# Expert Report to the NSW IPC on the Greenhouse Gas and Climate Implications of the Glencore Glendell Continued Operations Coal Project (SSD 9349 and SSD 5850 Mod 4)

## Response to Additional Material

Dr Penny D Sackett  
Distinguished Honorary Professor  
ANU Institute for Climate, Energy and Disaster Solutions

22 April 2022

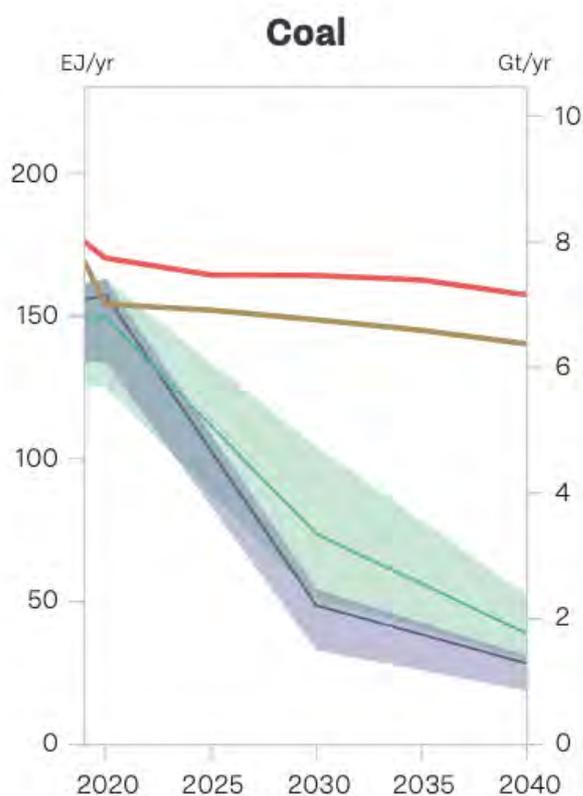
16) It is important to point out that **Glencore’s Production Cap is a business-as-usual statement**, namely that Glencore intends to maintain coal production at about 145 Mtpa for the foreseeable future. This is **completely inconsistent to holding global warming to 2°C, let alone well-below 2°C as science and the Paris Agreement support**. This is made clear in Figure 1 below, which shows that holding warming to 2°C or below requires an immediate, substantial, rapid and sustained *decline* in coal production. **Simply put, constant coal production leads to rising temperatures that are increasingly dangerous with a moderately high risk of being catastrophic.**<sup>7</sup>
